City of Keene Planning Board

AGENDA

Monday, March 24, 2025 6:30 PM City Hall, 2nd Floor Council Chambers

- b) **PB-2024-20 – Earth Excavation Permit Major Amendment & Hillside Protection Conditional Use Permit – 21 & 57 Route 9** – Applicant Granite Engineering LLC, on behalf of owner G2 Holdings LLC, proposes to expand the existing gravel pit located at 21 & 57 Route 9 (TMP#s 215-007-000 & 215-008-000). A Hillside Protection CUP is requested for impacts to steep slopes. Waivers are requested from Section 25.3.1.D & Section 25.3.13 of the LDC related to the required 250' surface water resource setback and the 5-ac excavation area maximum. The parcels are a combined ~109.1-ac in size and are located in the Rural District.

Figure 2. A snippet of the proposed BLA plan showing the area and amount of land to be transferred between the two parcels.

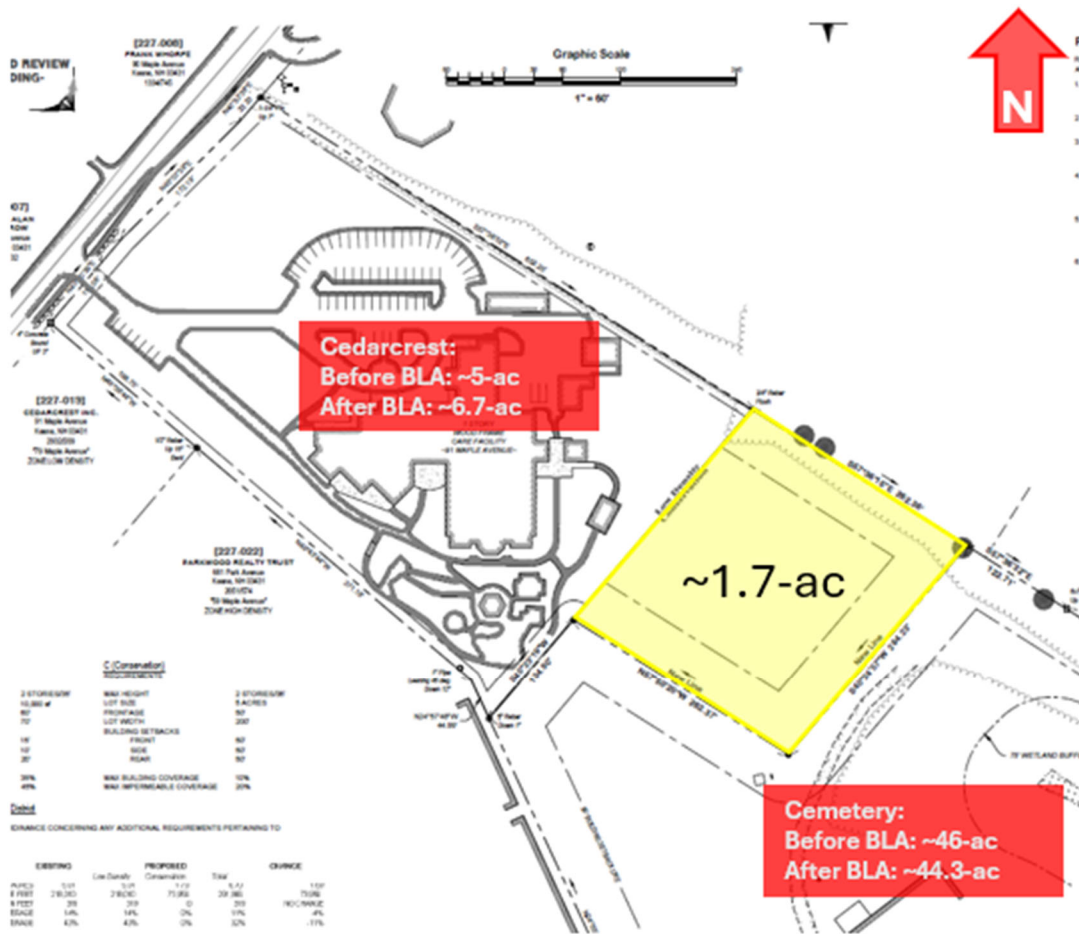
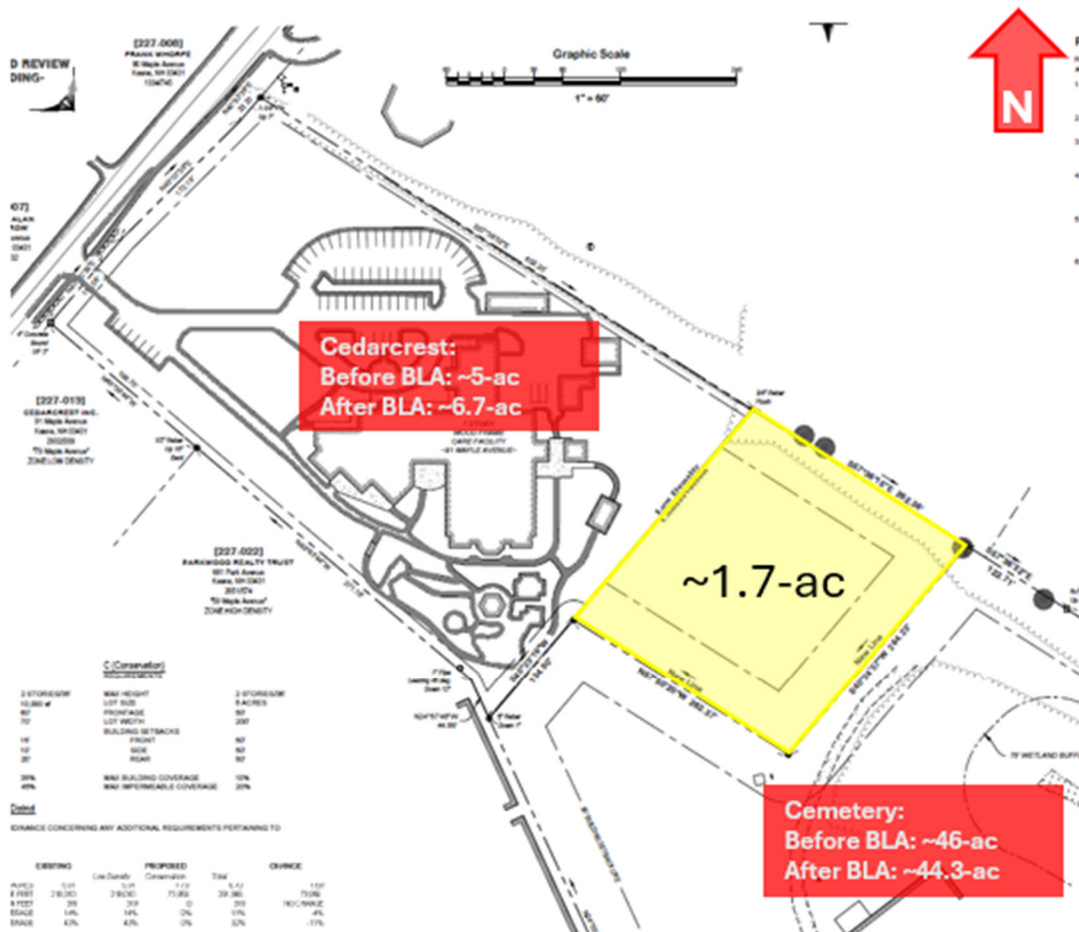
Line Adjustment, PB-2025-05. Following the BLA, the Cedarcrest property will become split-zoned with the main site located in the Low Density District and the newly acquired ~1.7-ac portion of the parcel located in the Conservation District. A Variance to allow for the primary use of the ~1.7-ac portion of the parcel as a medium-scale solar energy system was granted by the Zoning Board of Adjustment (ZBA) at their meeting on March 3, 2025. Figure 2 shows the area of land to be transferred to Cedarcrest from the City owned Monadnock View Cemetery parcel at 521 Park Ave.

Figure 3. A snippet of the proposed conditions plan showing the proposed location and extent of the solar array on the Cedarcrest site.

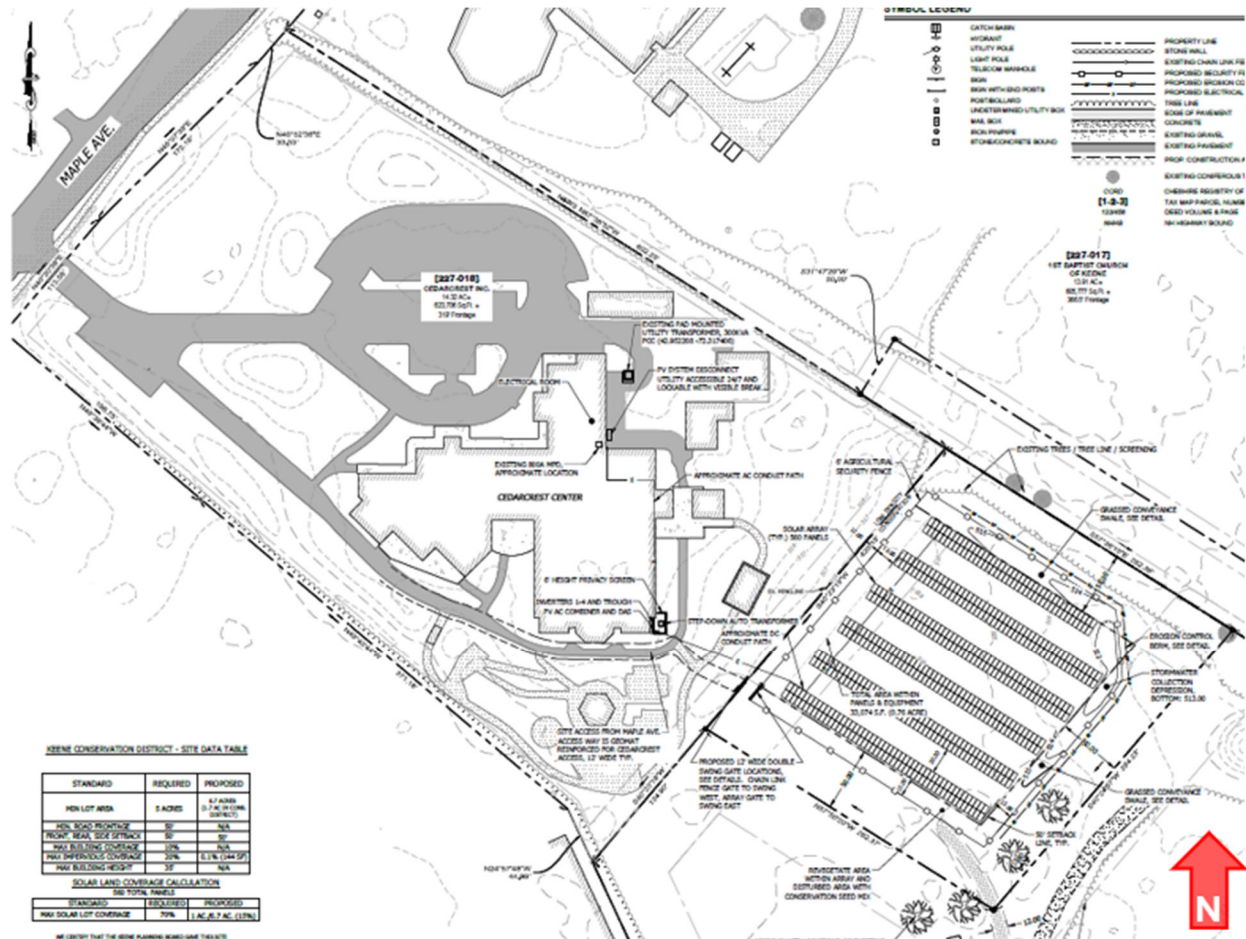
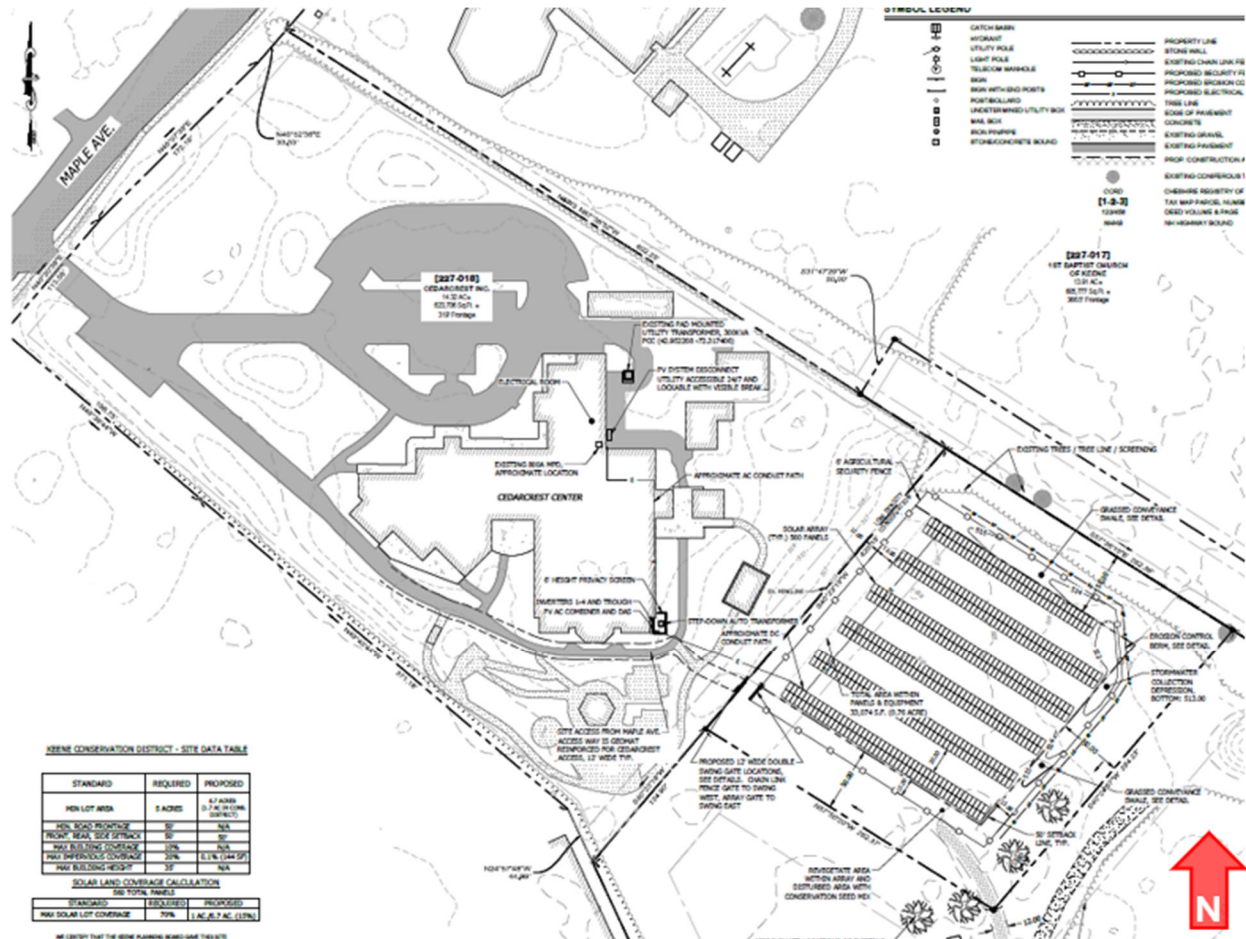
The proposed conditions plan on Sheet C2.0 of the plan set, which can also be seen in Figure 3, indicates that the solar footprint of the array will be ~0.76-ac (~33,074-sf) in size, which makes this a medium-scale solar array as defined under Section 8.3.7.B.1 of the LDC. This standard appears to be met.

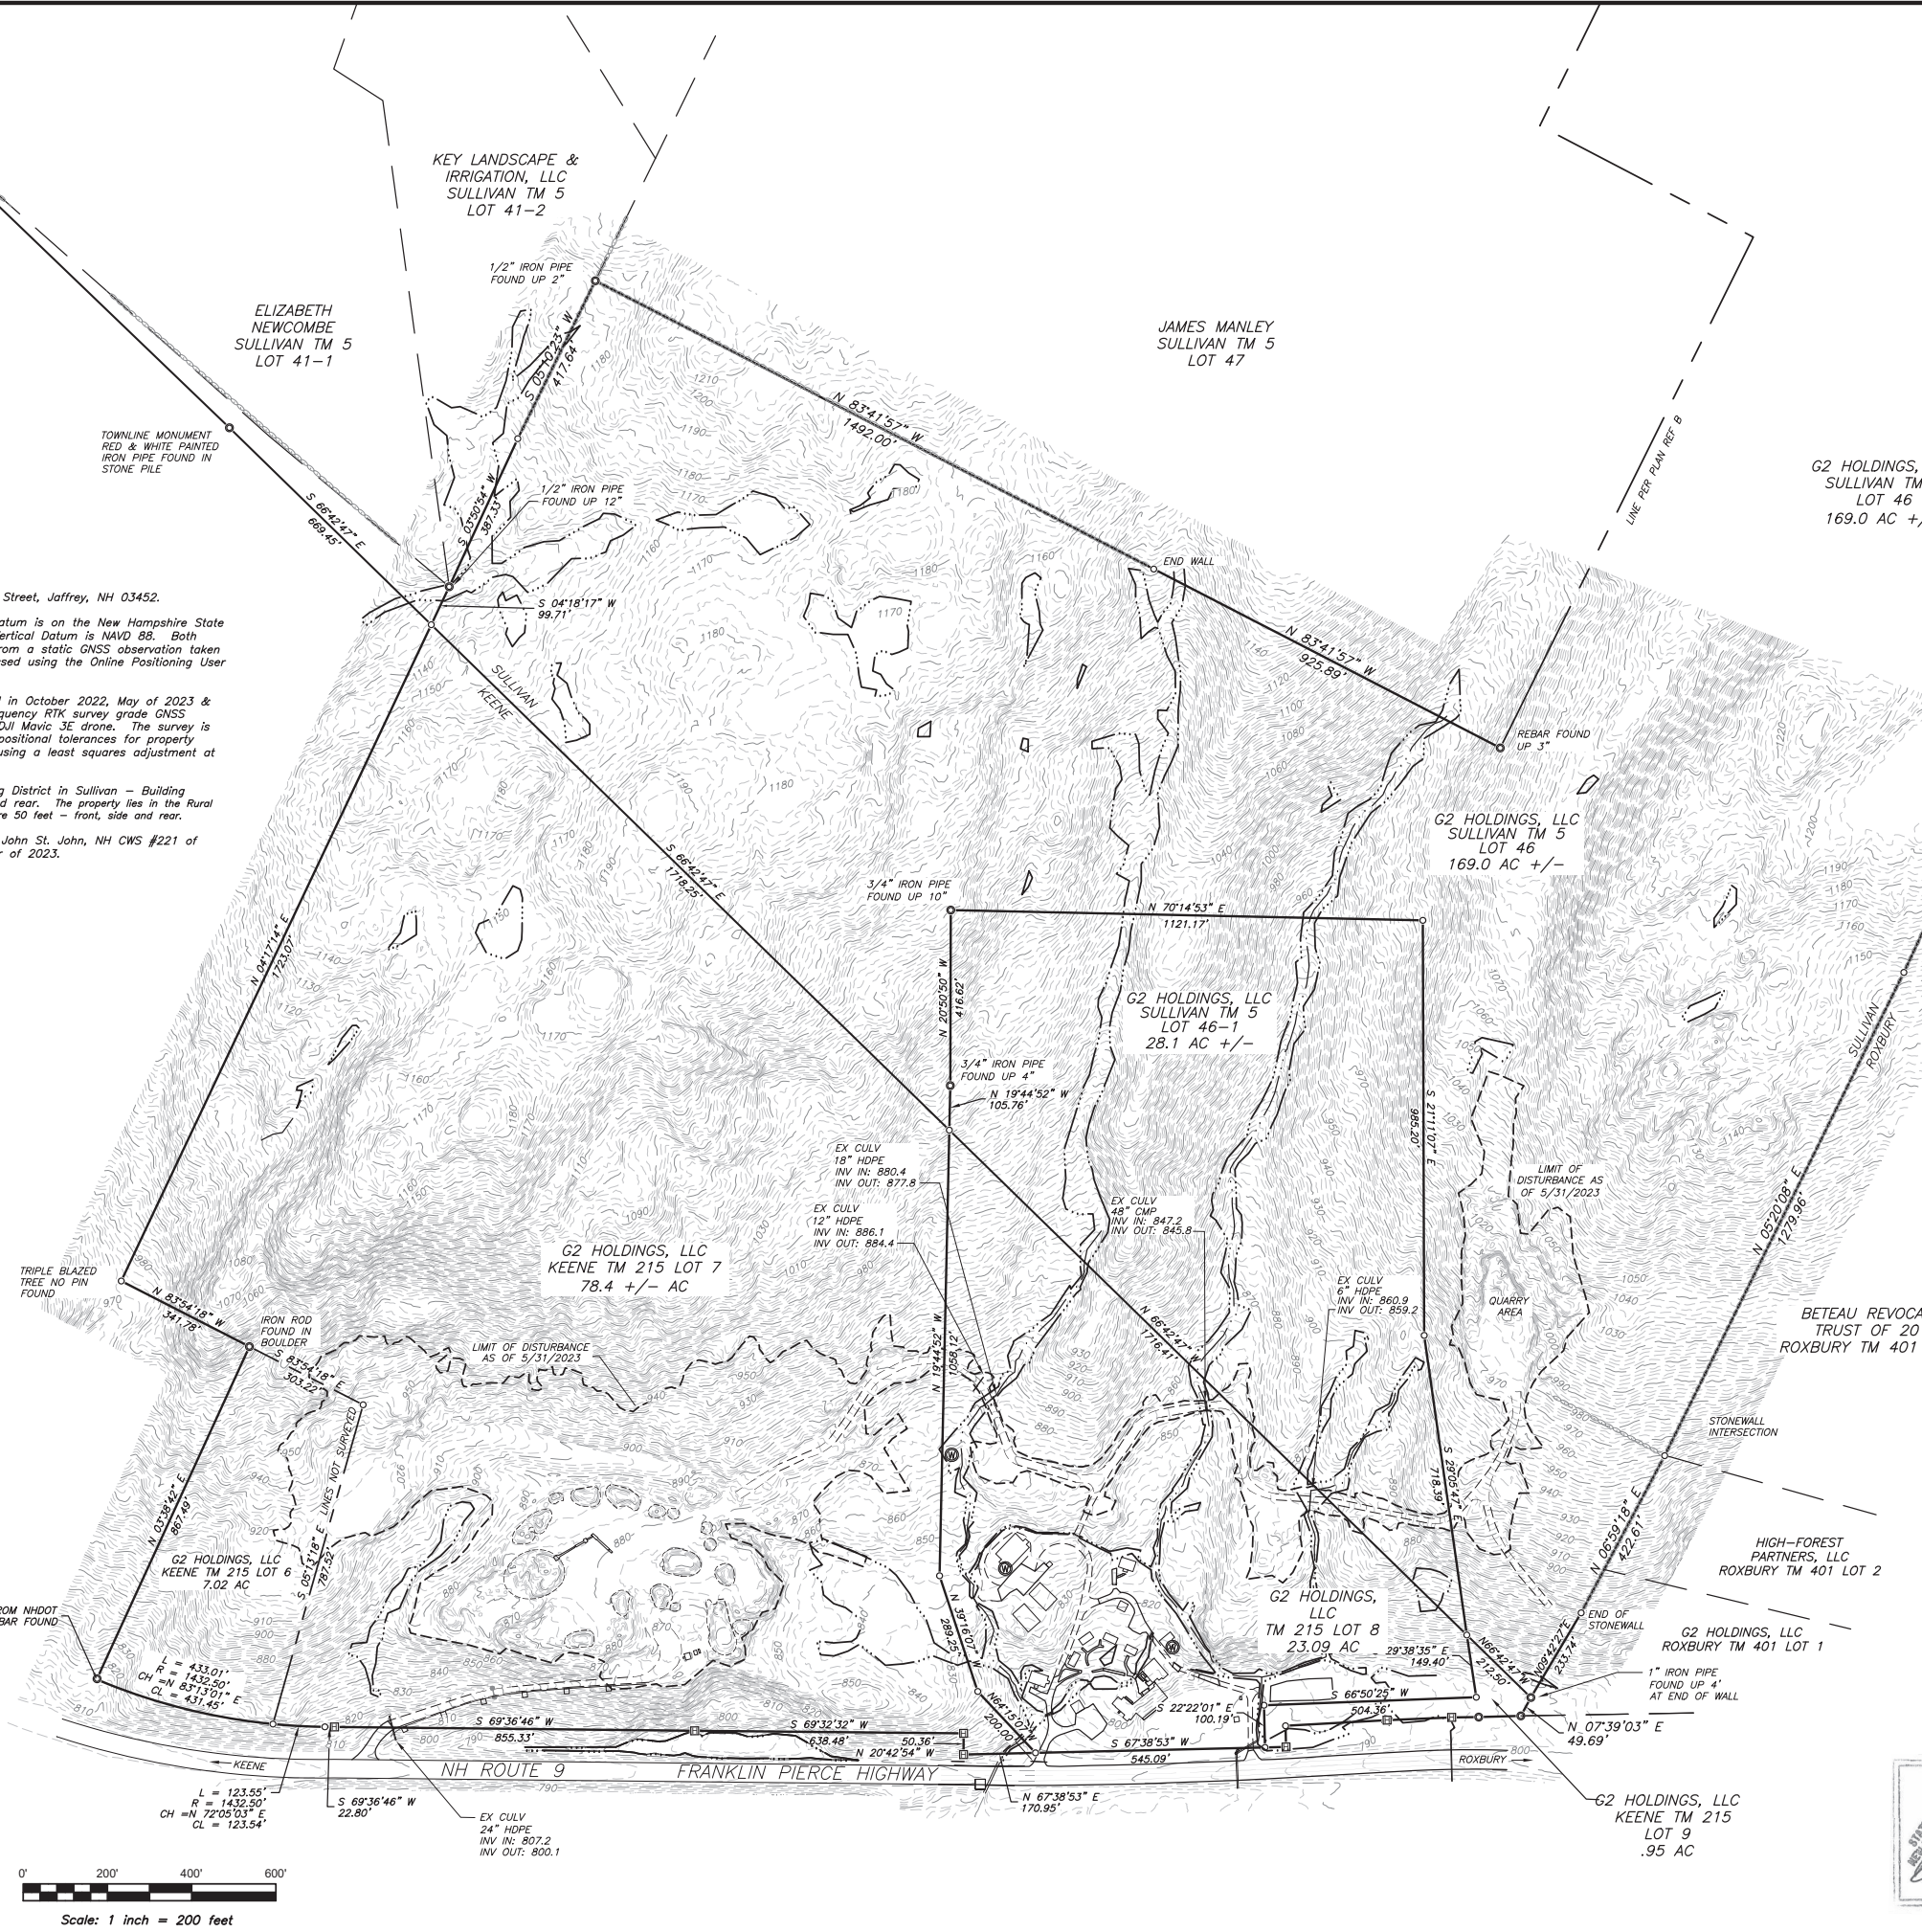
- c. Have the certified wetlands scientist stamp the Overview plan on Sheet 1 of the plan set.

7. Rock Crushing Plant: Please submit information about the “rock-crushing plant” referred to under Note #8 in the “Operation Notes” section on Sheet 1 of the plan set.

1. Plan sheet 1 of 19, General Note#20 specifies that 'no excavation will be performed within 75' of the wetlands or 300' from an abutting property. Vegetation shall be maintained or provided within the peripheral areas previously listed.' It is not clear what area(s) are being referenced and what (if any) plantings are proposed. A landscaping plan should be provided, reviewed and approved in conjunction with this note/requirement.

2. Plan sheet 1 of 19, General Note#26 specifies that 'the estimated project time frame will exceed five years and is subject to change...' This project schedule is insufficiently detailed and should establish requirement deadlines for either completing and/or resubmitting and providing an update and request for extension for the completion of the project in conformance with the City of Keene Land Use Ordinances.

3. Plan sheet 1 of 19, General Note#23 specifies that 'plowed snow from the operations shall be maintained on site within the contained area' The snow stockpile areas and associated maintenance should be specified on the plans for clarity.

4. Plan sheet 1 of 19, Operation Note #9 specifies that ‘No fuels, lubricants or other toxic or polluting materials shall be stored on site...’ Specify on the plans the proposed fueling areas and allowances for fueling on site.

A certified wetland stamp has been added to the Overview plan on sheet 1 of the plan set.

More information regarding the rock-crushing plant has been added to Operation Note#8 on sheet 1.

General Note#26 on sheet 1 has been updated to provide more detail on the project schedule and requirement deadlines and is now referenced as note #25. Operation Note #25 has been added and includes the following: "An Earth Excavation Permit Renewal application shall be submitted to the City of Keene Community Development Department at least 6-months prior to the expiration of the approved permit period in accordance with Sec. 26.19.12 of the Land Development Code."
